Technical Service Information

FORD A4LD HARSH 1-2 SHIFTS

Figure 1

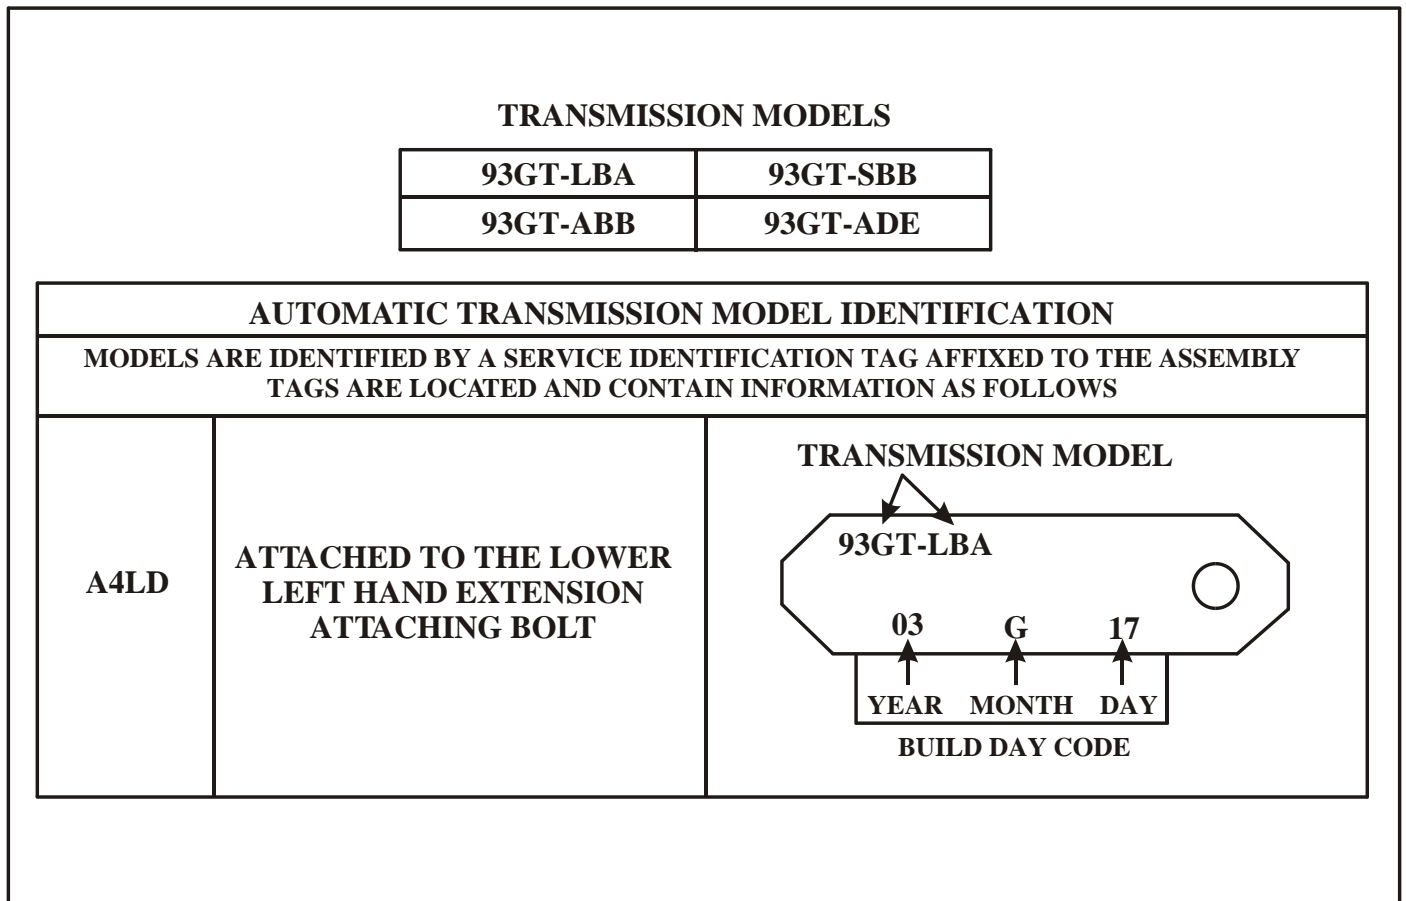
- COMPLAINT:** Some models of the Ford A4LD transmission found in 1993- 1994 Ford Rangers may display a harsh 1-2 upshift.
- CAUSE:** The cause may be the calibration of the Intermediate Servo Release (TSR) accumulator spring, located in the valve body..
- CORRECTION:** Perform the On-Board Diagnostic procedures to verify that no other concerns and/or trouble codes exist. If no other concerns exist, refer to the chart in Figure 1 to ensure that the transmission model you are servicing is listed. If it is listed, replace the Brown production intermediate servo release spring with a White (re-calibrated) service spring, available under part number E4TZ-7F261 -AVMR. Refer to Figure 2 for ISR accumulator spring location in the valve body.
- NOTE:** *Performing the above procedure on transmission models that are not listed in Figure 1, may result in damage to the transmission.*

ISR Accumulator Spring (White - Re-calibrated) E4TZ-7F26 1 -AVMR
